WATER PERMIT NO. 1795-1

**SOUTH DAKOTA
WATER PERMIT NO. 1795-1**

P&S Review

Water Permit Application No. 1795-1
Sandy humpert

1795-1

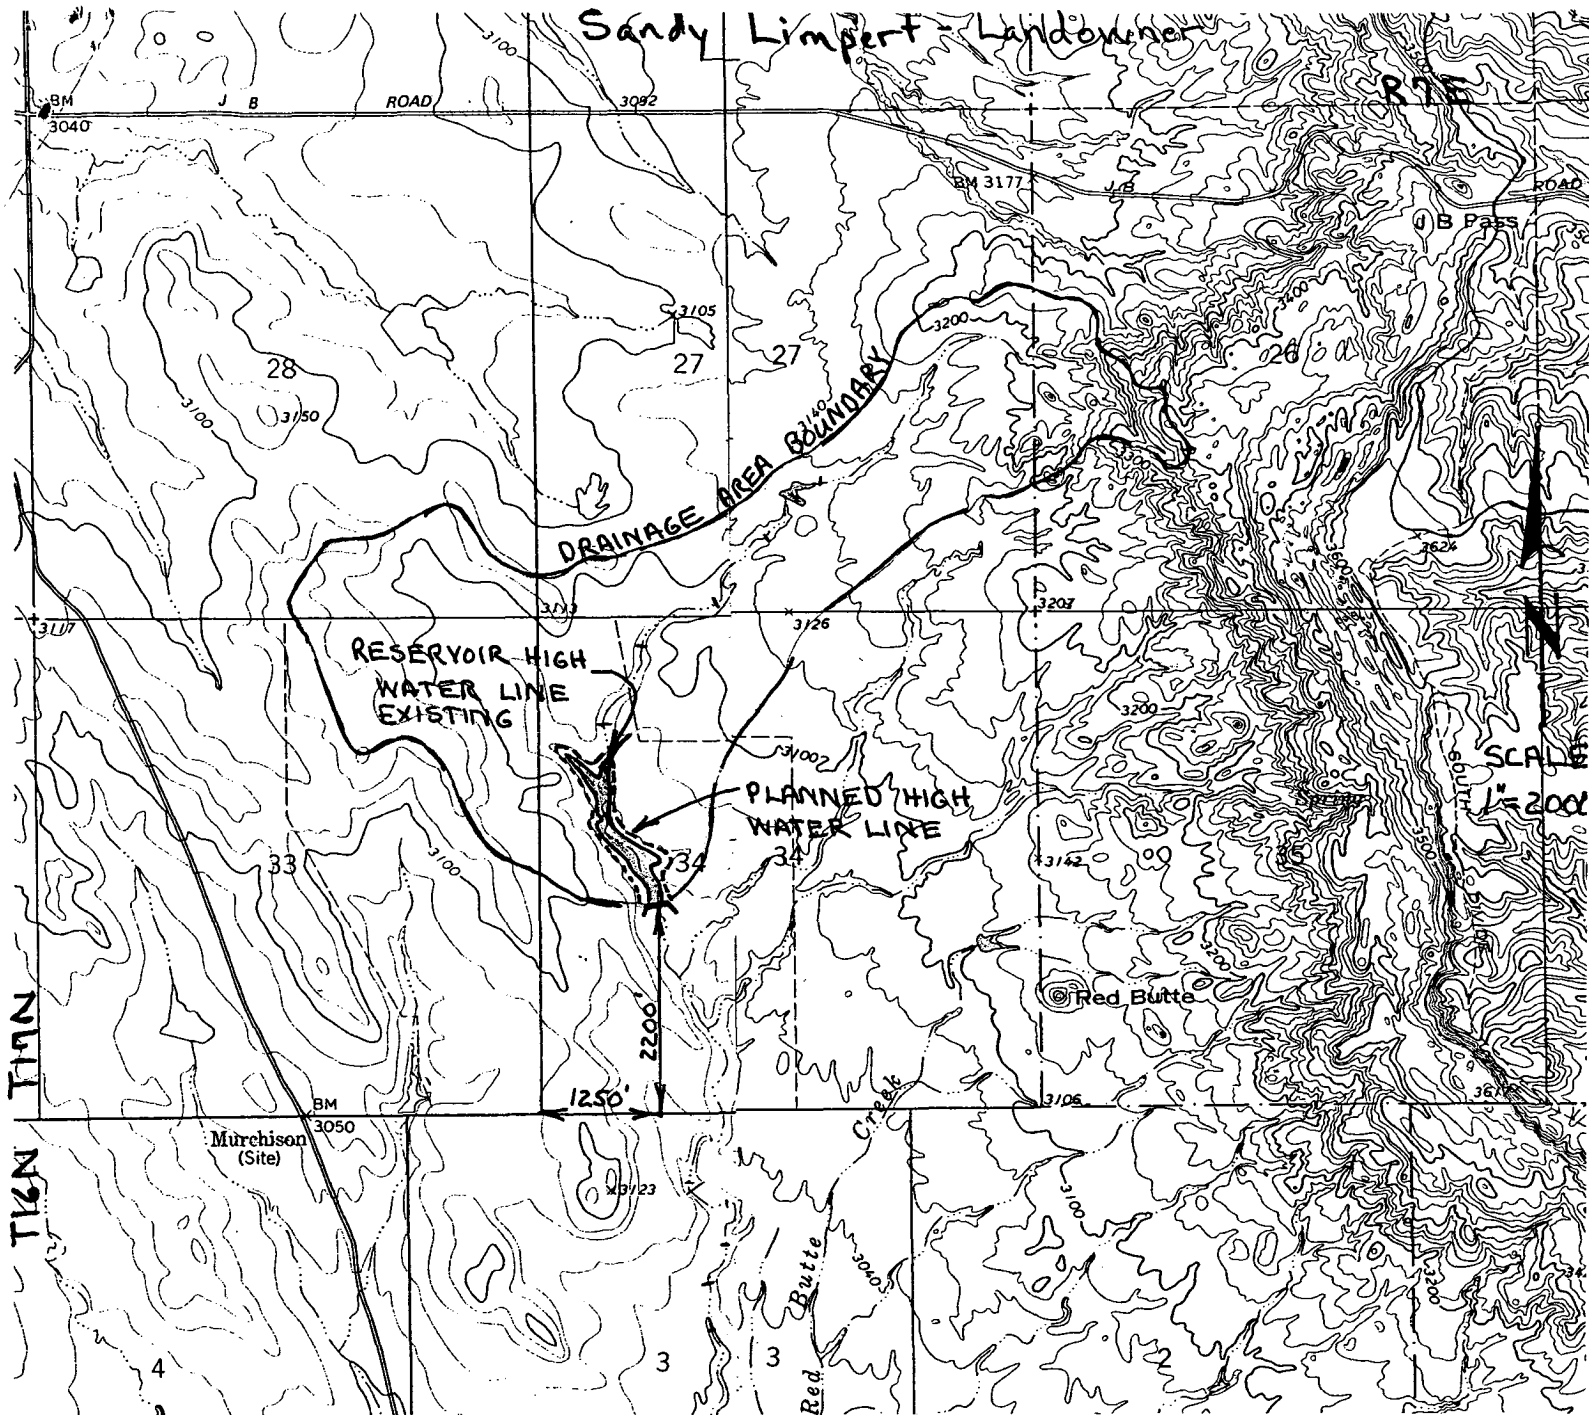
A written preliminary risk assessment of the downstream hazard potential needs to be provided to aid in determining the hazard classification for the dam. The hazard classification for the dam (Category 1, 2 or 3) needs to be known in order to determine what provisions of the Safety of Dams Rules will apply to your dam. The risk assessment needs to be prepared by an engineer as defined in the Safety of Dams rules. Thomas D VerHelst, with the Conservation Service will be able to assist with the risk assessment. The plans and specifications for the dam are also required.

Enclosed are the plans and specifications for the Sandy Limpert Dam Restoration Project as well as a preliminary risk assessment.

SKETCH PLAN OF DAM AND RESERVOIR AREA

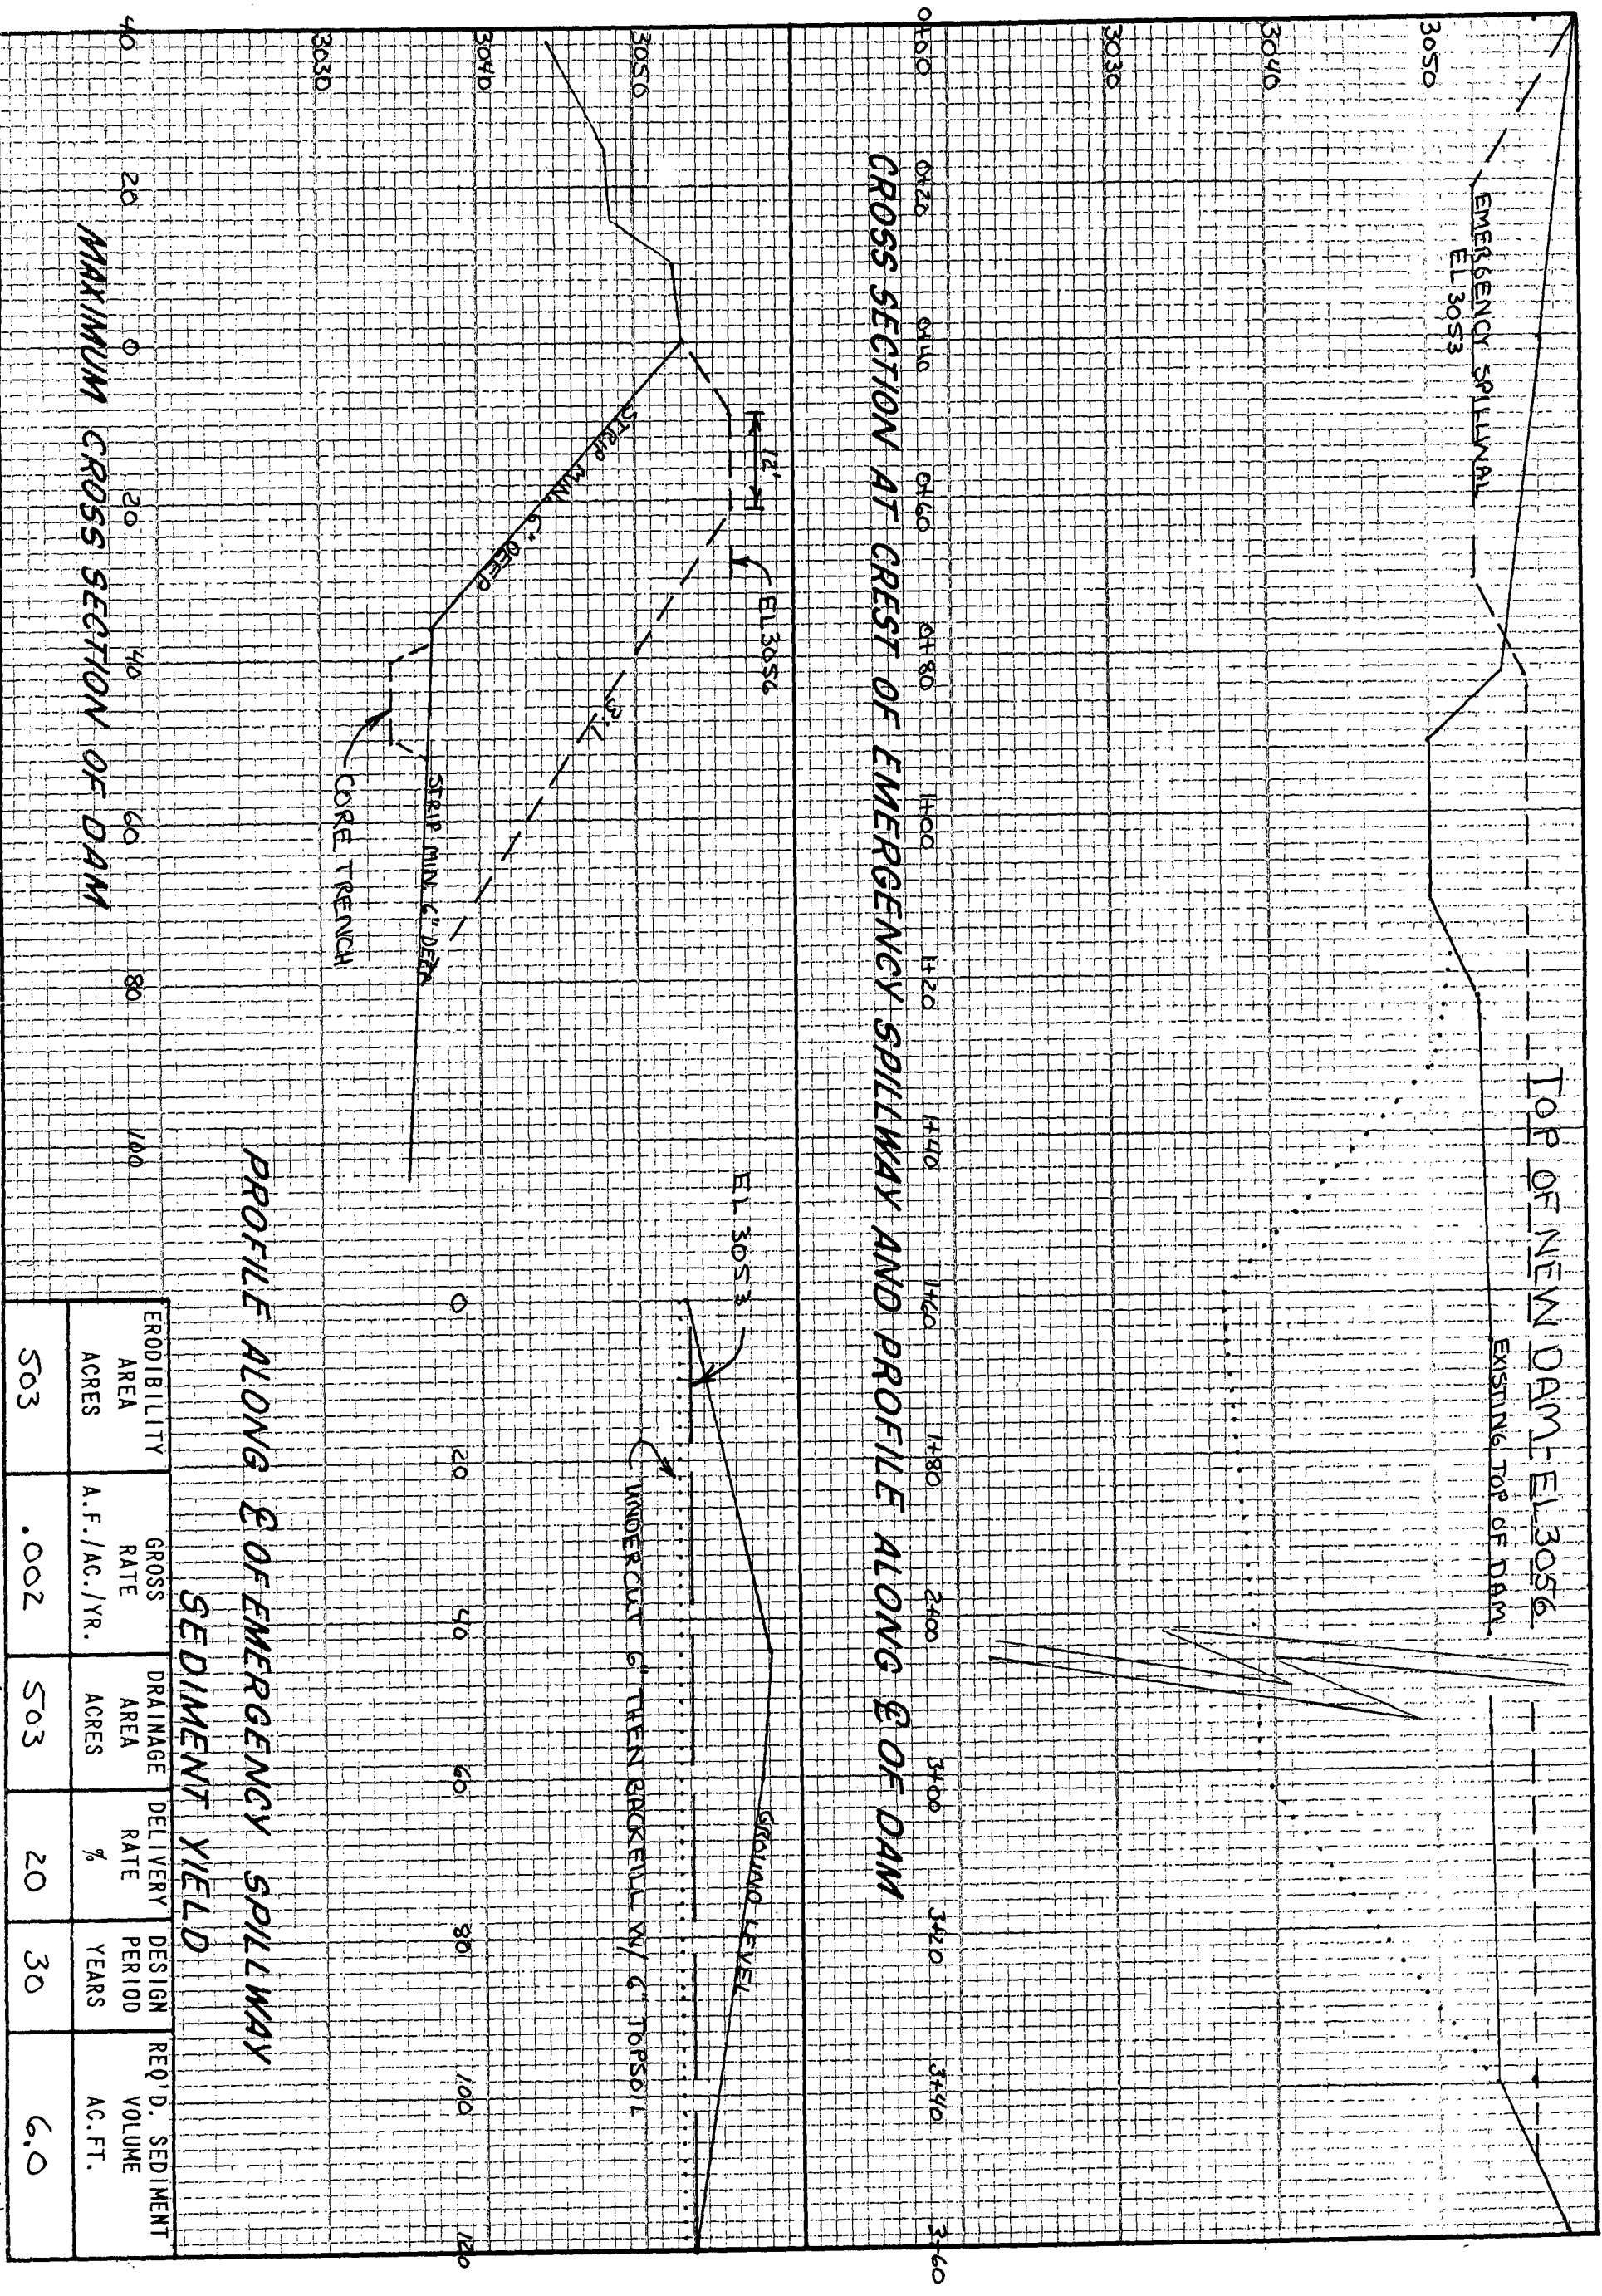
Top of Dam Elev. - 3056
Spillway Elev. - 3053
Dis. Ent. Top Elev. - 3036 } Ht. = 20 ft. Cat. 3 - Low Hazard Dam

Normal Capacity = 40 Ac-Ft
Max Capacity = 62

Max Capacity x Ht = 62 x 20 = 1240 < 3000 $\therefore$ 25 year
Minimum Spillway Design

1. Topo Map - OK
2. Dam Axis Profile - OK
3. Dam Max Xsec - OK
4. Area Capacity - OK
5. Outlet Details - OK
6. Spillway Rating - OK
7. Spillway Details - OK
8. Specs - Std NRCS - OK
9. E-PP - Cat. 3 N/A - OK

The Limpert Dam will be classified as a small size Category 3, Low Hazard dam with a dam height of 20 feet and a normal storage capacity of 40 acre-feet and a maximum storage capacity of 62 acre-feet.
